# Product Change Notification (PCN) Announcement

Title	E1.S 4TS2-P PCBA Change Notice	Date	2025/May/27	Ref No.	F250037
Models	E1.S 4TS2-P				
Level	<input type="radio"/> Critical <input type="radio"/> Major <input type="radio"/> Minor <input checked="" type="radio"/> Notice	Change Type	Hardware - PCB		
Description					
This PCN is being issued to address that selected Innodisk E1.S 4TS2-P products are going to change PCBA design.

PCBA Before Change:

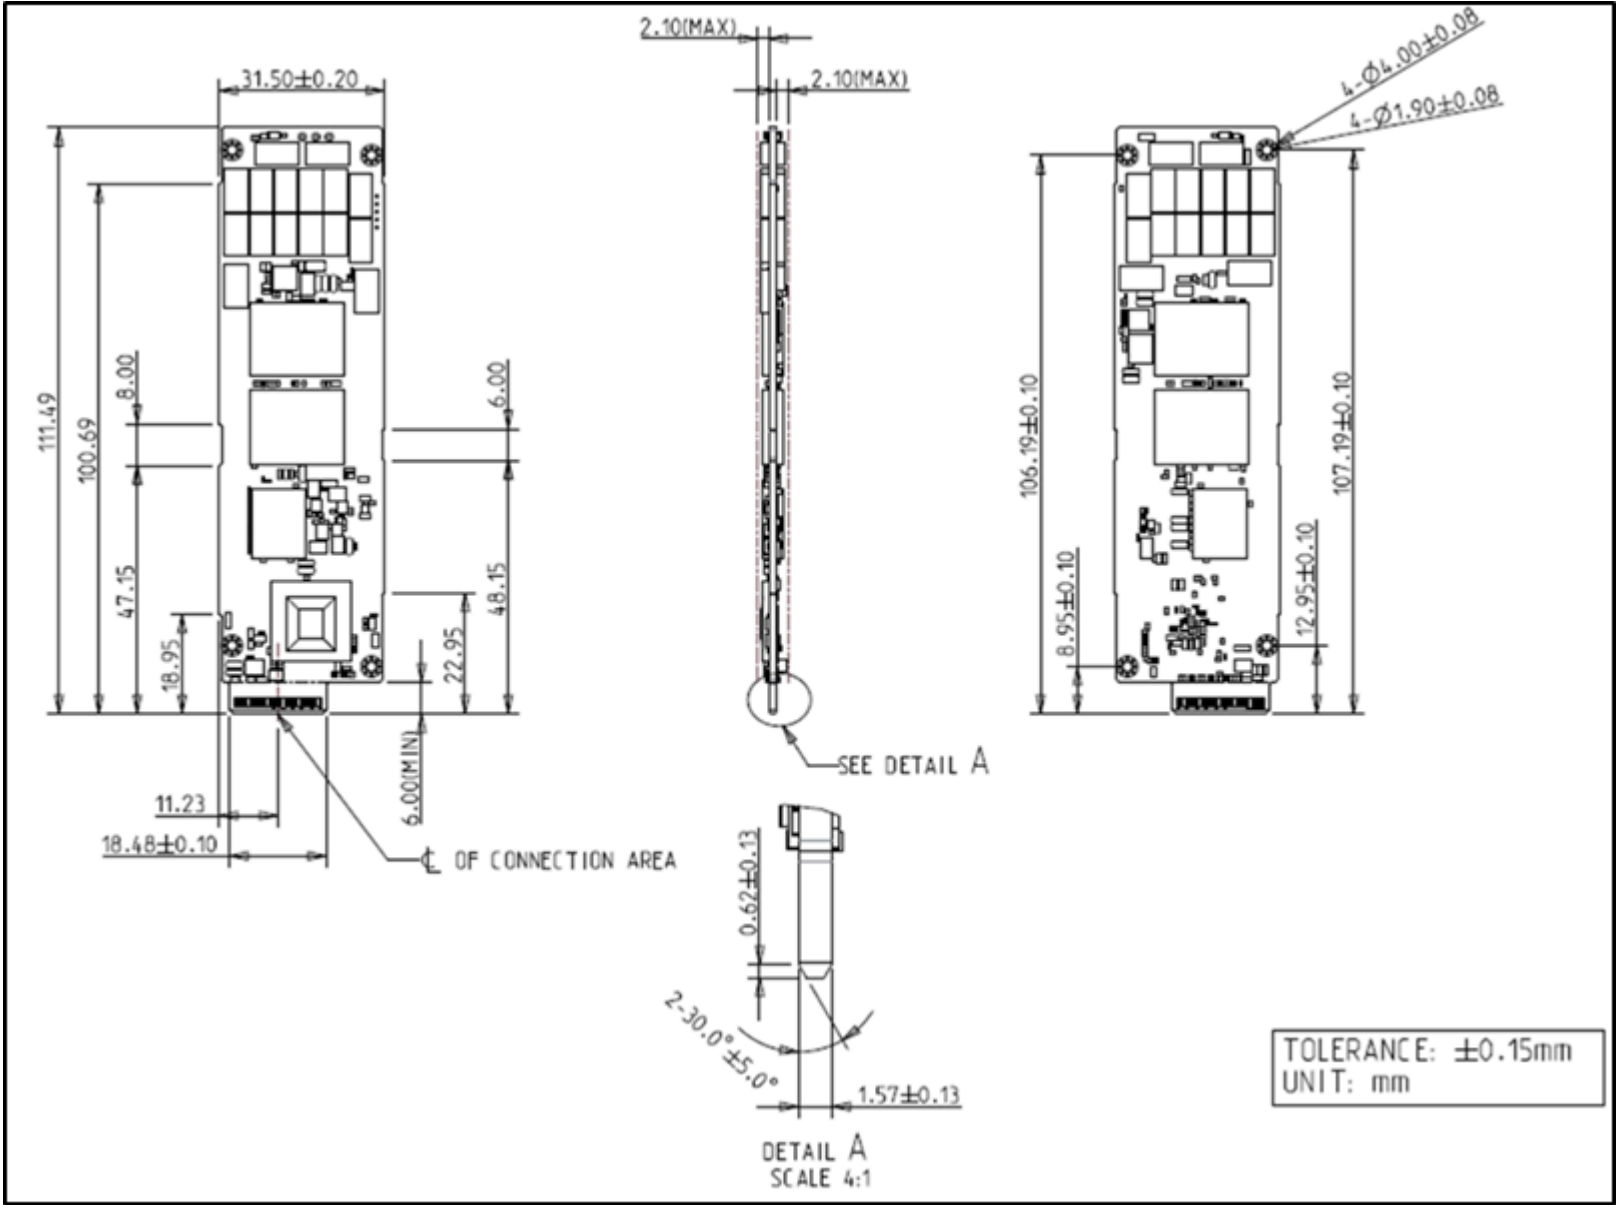
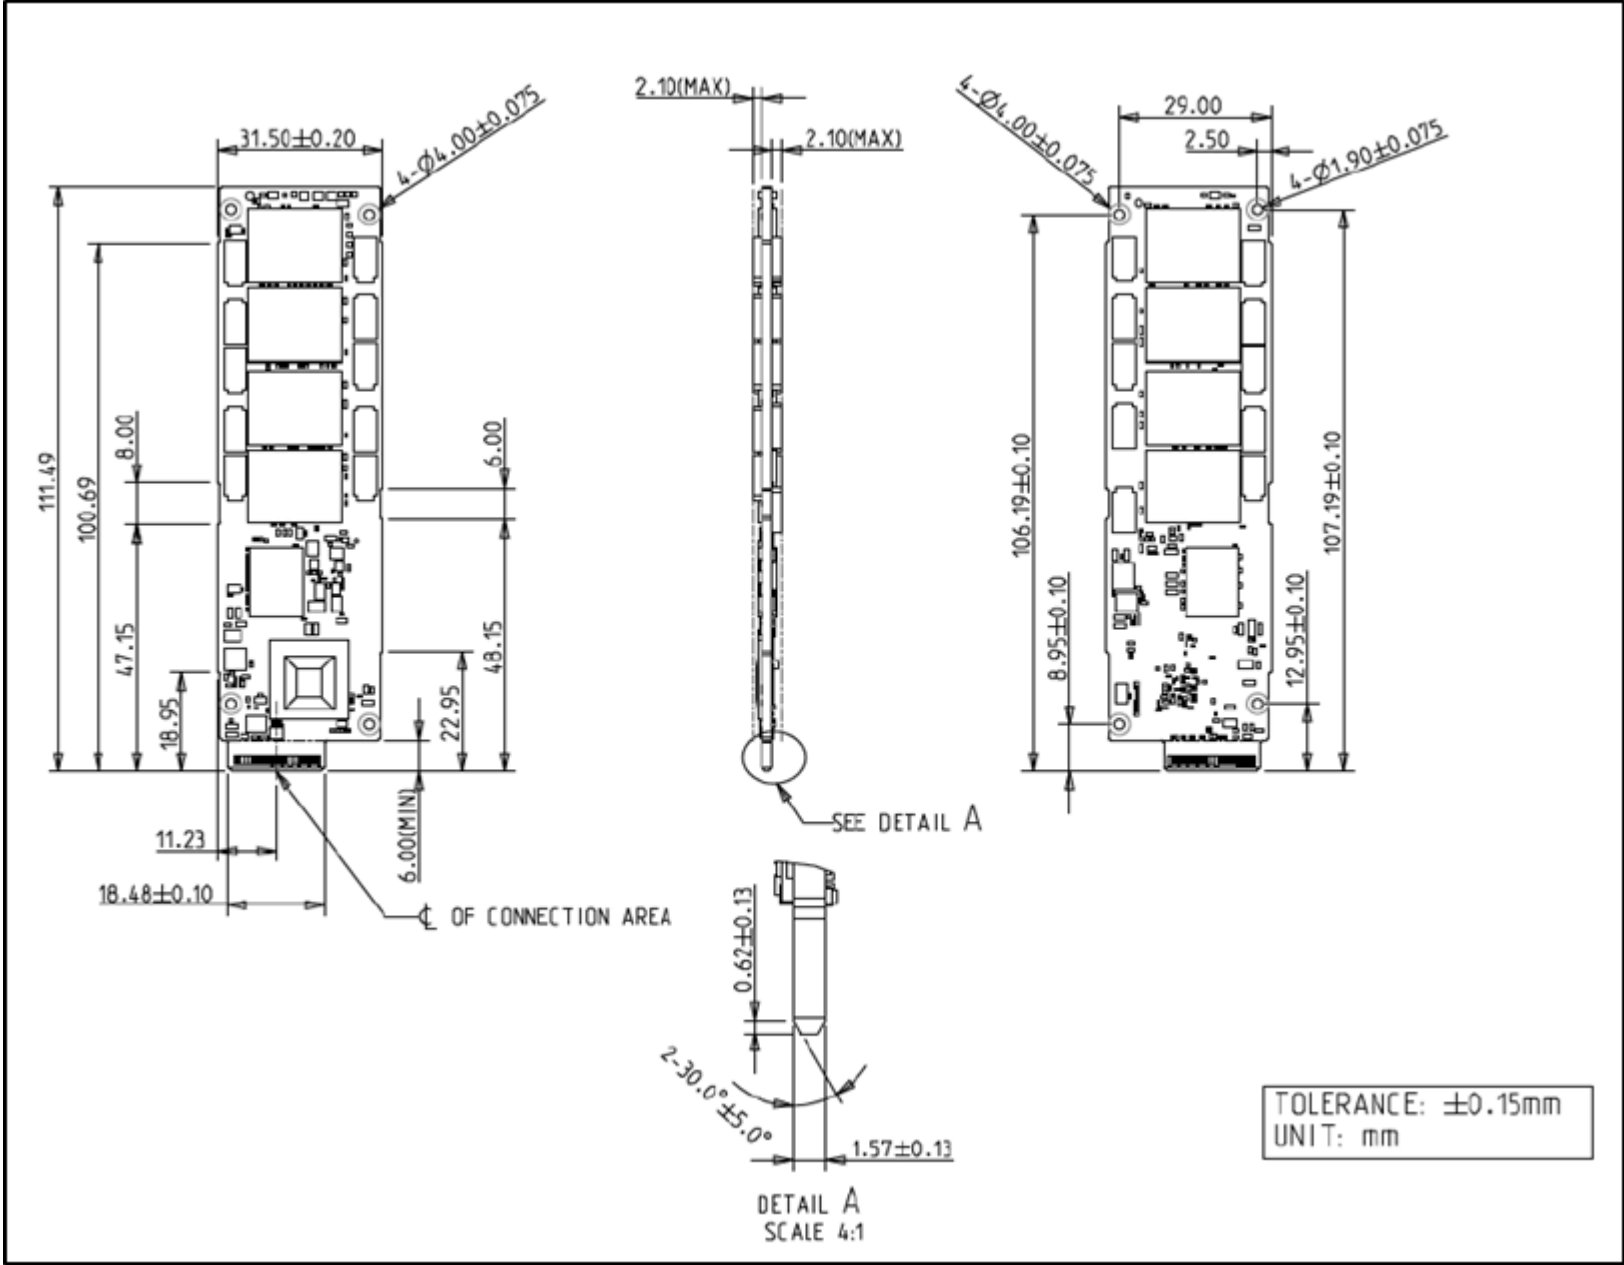
Selected E1.S 4TS2-P products adopt new PCBA design for better power-loss-protection (PLP) efficiency.

PCBA After Change:

The mechanical dimensions of E1.S products with 9.5mm and 15mm housings are not affected.
